Denial Memorandum

Applicant: Kevin & Amanda Karl

Address: 17 Heathcliff Road, Rumson, NJ 07760
Block 119, Lot 5, Zone: R-1

PROPOSED ADDITION & ALTERATION
KARL RESIDENCE
17 HEATHCLIFF ROAD
BOROUGH OF RUMSON, NEW JERSEY

1 SITE KEY PLAN

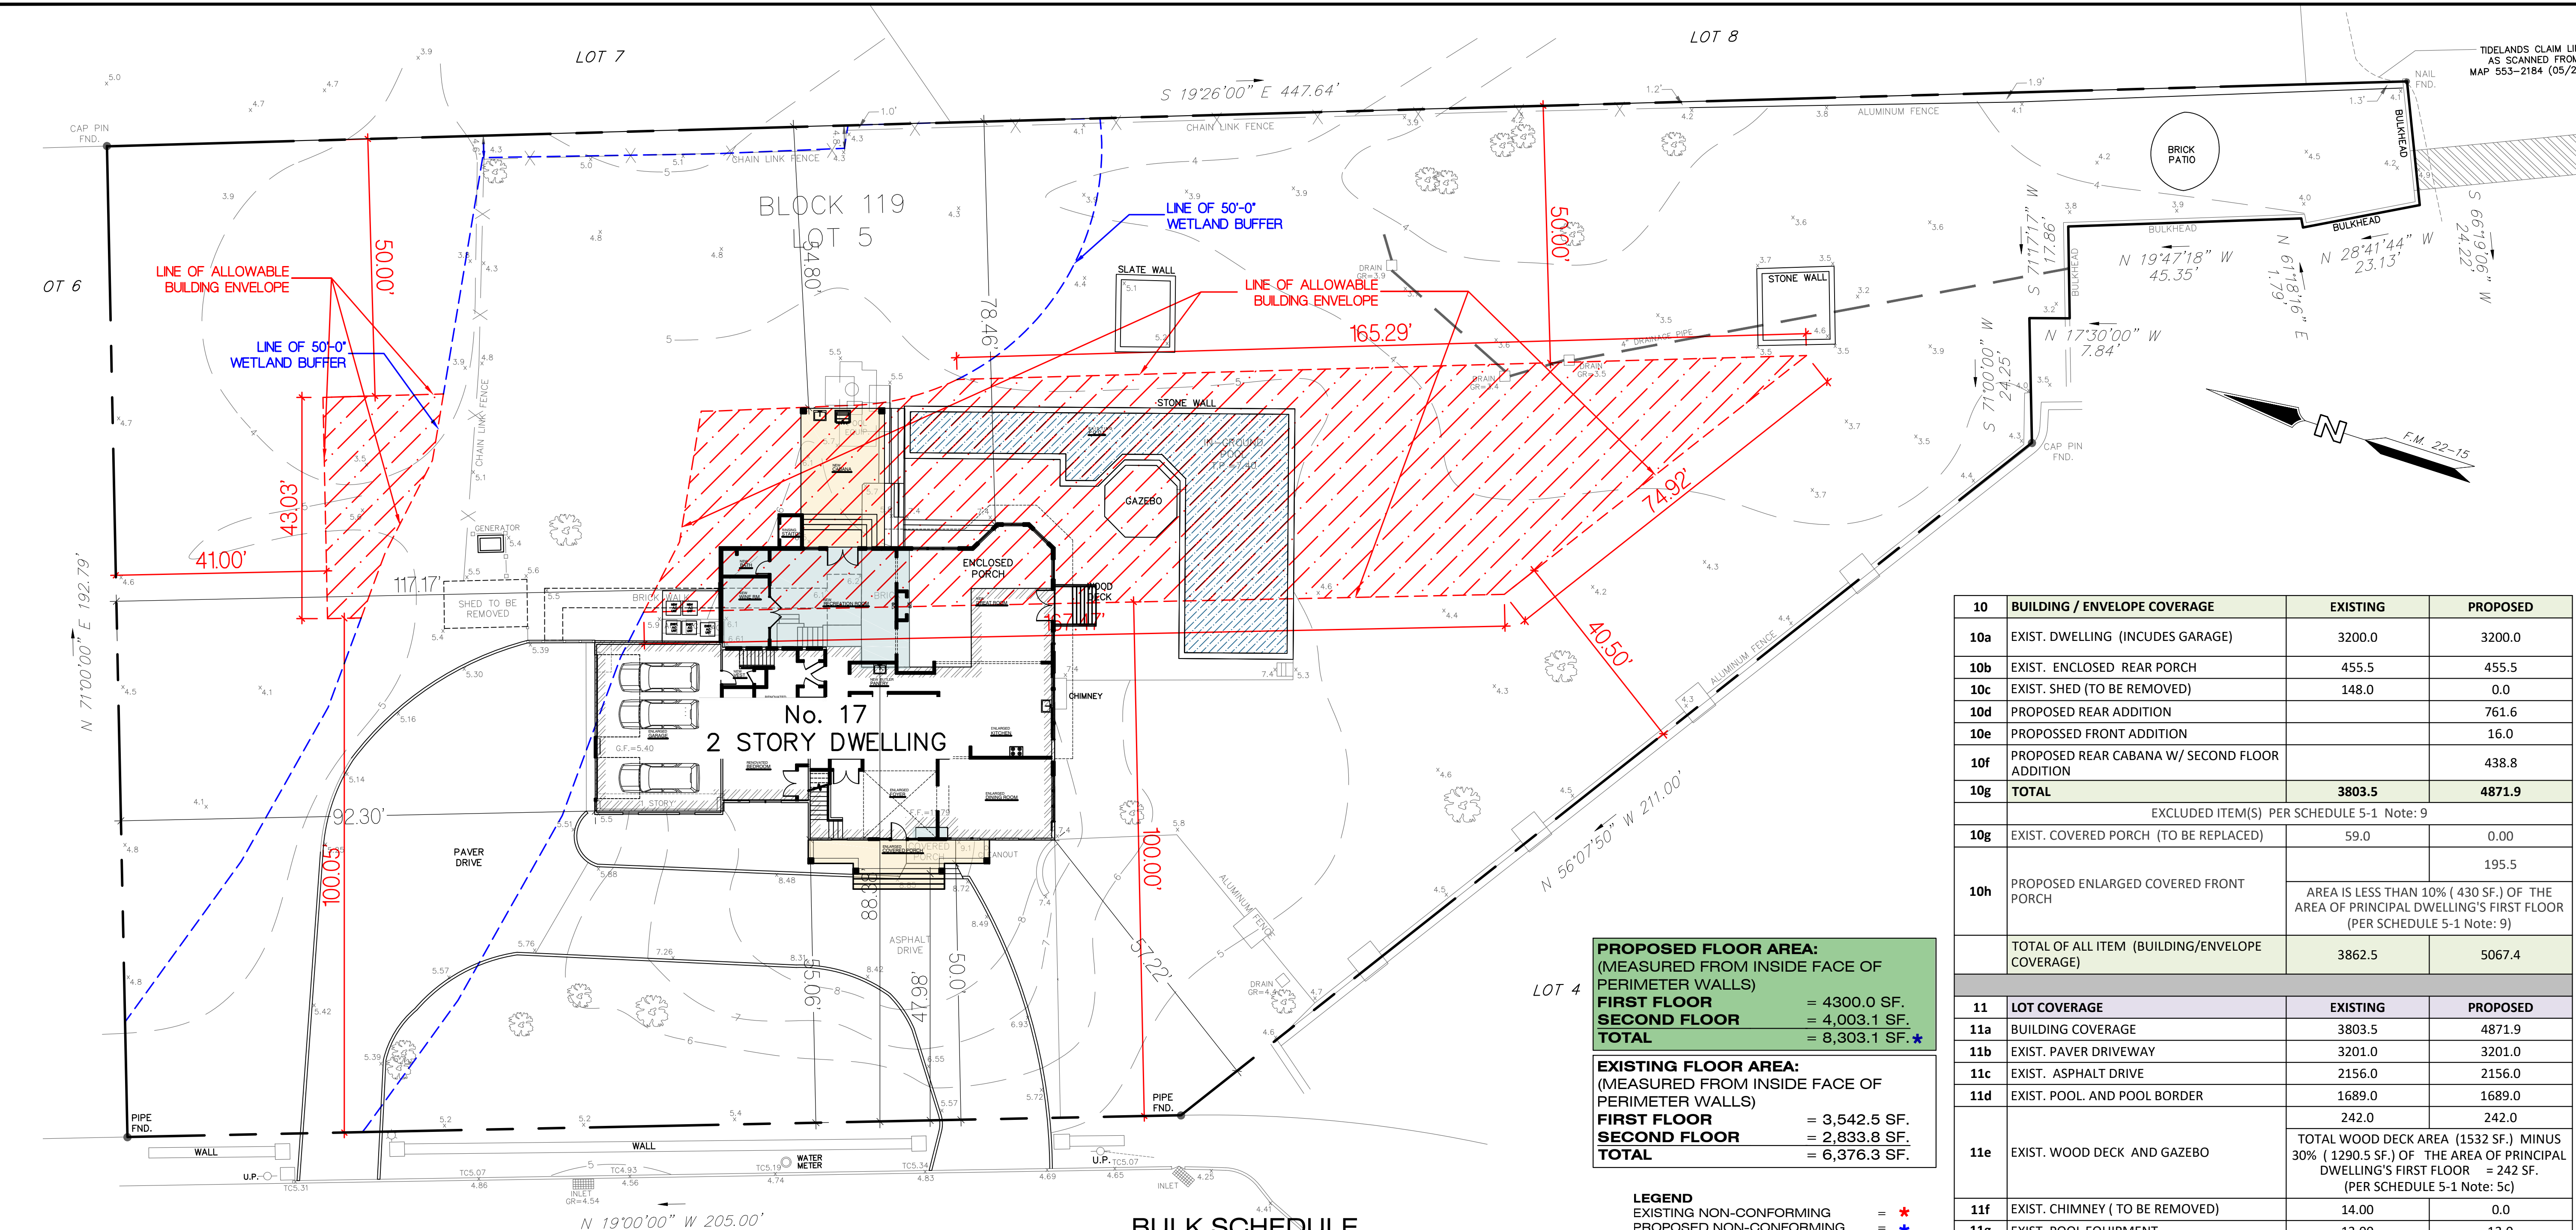
- Expansion of habitable space in a nonconforming dwelling **(22-7.3 New)**
- (Schedule 5-1) Bulk Variances
 - Front yard setback: 100' required, 50' existing / 47.98' proposed. **(New, Intensified)**
 - (Rear addition) Uniquely, the rear addition is partially located in the front yard setback. **(New)**
 - Minimum Lot Area: 1.5 acre required / 1.46 acre exists **(Existing, unchanged)**
- (Schedule 5-3) Floor Area: 7,980 square feet permitted / 8,303.1 square feet proposed. **(New)**
- (Schedule 5-3) Floor Area Ratio (FAR): 0.124 permitted / 0.130 proposed **(New, D-variance)**
